Access Compliance Report

Public Rights-of-Way

(Curb Ramps)

Intersection ID: 28311	Main Street: POMERANE_PL	Cross Street: ZACKERY_AV	Location: NW
ADA ID: 18C080EF100A	Ramp Type: PerpDiag	Initial Pass/Fail: Fail	Overall Compliance: No
		Severity Score: 37.5

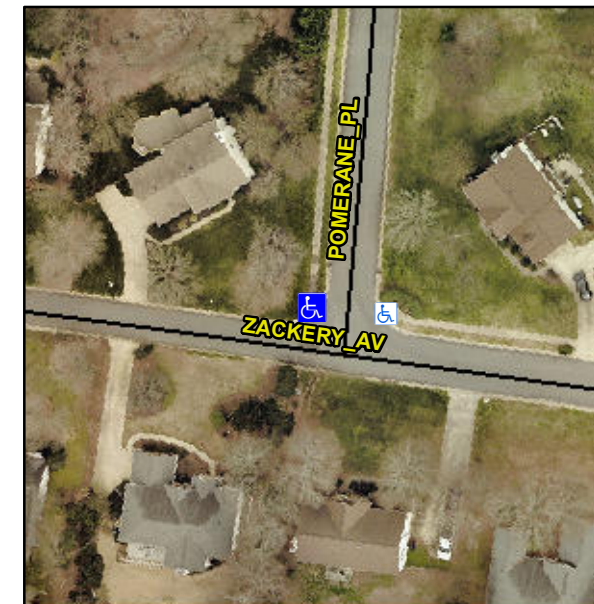
Not Found, R304.2.2, R304.5.3

Compliance	Description	Data	Compliance	Description	Data
N/A	Ramp Length (in)	96.0	No	Ramp Slope (%)	10.5
Yes	Ramp Width (in)	77.0	No	Ramp XSlope (%)	7.1
N/A	Flare Type LT	N/A	N/A	Flare Type RT	N/A
N/A	Flare Slope LT (%)	N/A	N/A	Flare Slope RT (%)	N/A
N/A	Flare Traversable LT?	N/A	N/A	Flare Traversable RT?	N/A
N/A	Landing Length (in)	N/A	N/A	DWS Provided?	N/A
N/A	Landing Width (in)	N/A	N/A	DWS Contrast?	N/A
N/A	Landing Slope (%)	N/A	N/A	DWS Length (in)	N/A
N/A	Landing X Slope (%)	N/A	N/A	DWS Full Width?	N/A
N/A	Landing Curb? (Y/N)	N/A	N/A	DWS Offset (in)	N/A
N/A	Shared Landing?	N/A			
N/A	Gutter Ponding?	N/A	N/A	Gutter Slope (%)	N/A
N/A	Gutter Lip Ht (in)	N/A	N/A	Gutter X Slope (%)	N/A
N/A	Painted X Walk1?	No	N/A	Painted X Walk2?	No
	X Walk 1 Direction	To S		X Walk 2 Direction	To SE
N/A	X Walk 1 Width (in)	N/A	N/A	X Walk 2 Width (in)	N/A
	X Walk 1 Slope (%)	3.2		X Walk 2 Slope (%)	1.4
	X Walk 1 X Slope (%)	2.3		X Walk 2 X Slope (%)	1.5

Remove & Replace Curb Ramp With Two New Directional Ramps or Equivalent.
